PRODUCT / PROCESS CHANGE INFORMATION

1.1 Company		STMicroelectronics International N.V
1.2 PCI No.		MDG/22/13712
1.3 Title of PCI		ST25R3916/17/18/16B/17B, NFC Reader IC new product introduction with non-wettable thin QFN package
1.4 Product Category		ST25R3916/17/18/16B/17B-AQWT
1.5 Issue date		2022-10-11

ST25R3916/17/18/16B/17B, NFC Reader IC new product introduction with non-wettable thin QFN package

What is the impact of the change?

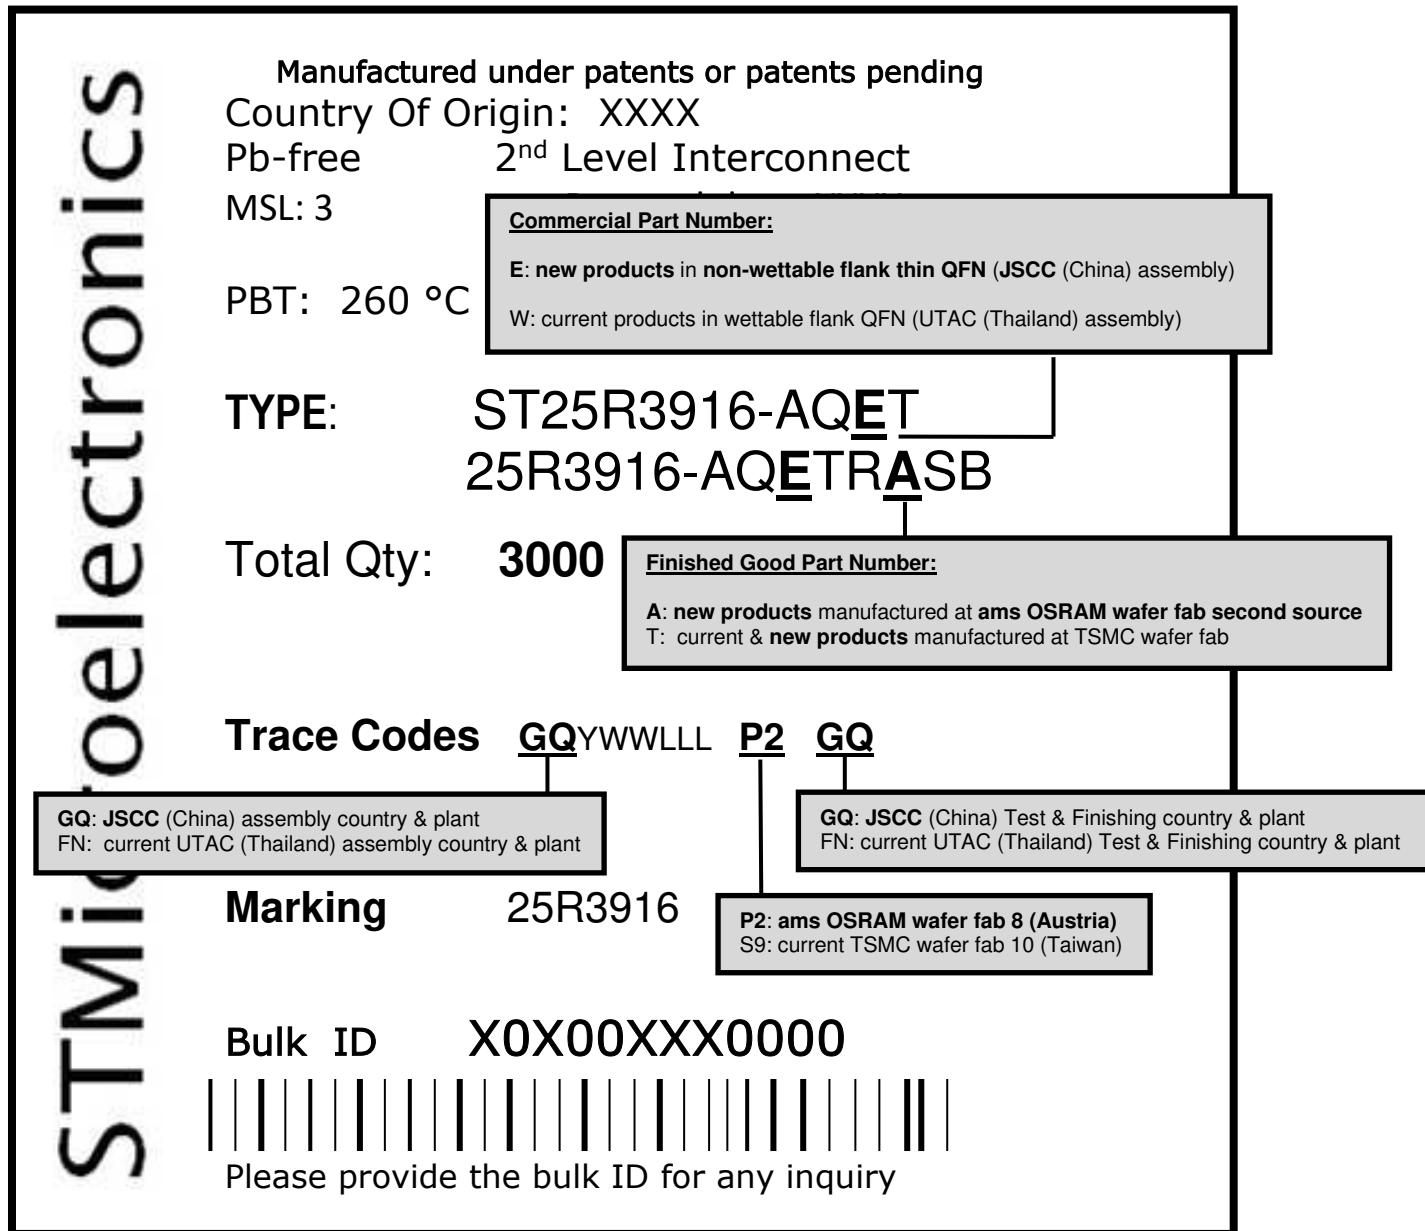
- **Form:** Marking change (see details next page)
- **Fit:** Package dimensions: Package thickness change and dimension of solder pin.
- **Function:** No change

- Form: DEVICE MARKING

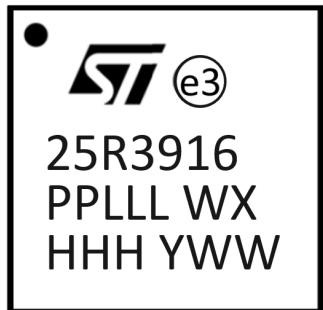
On the device marking, the change is visible inside the trace code where the Assembly Country & Plant “PP” is changing from FN to **GQ**. Also, the Country Of origin “HHH” is changing from THA to **CHN**.
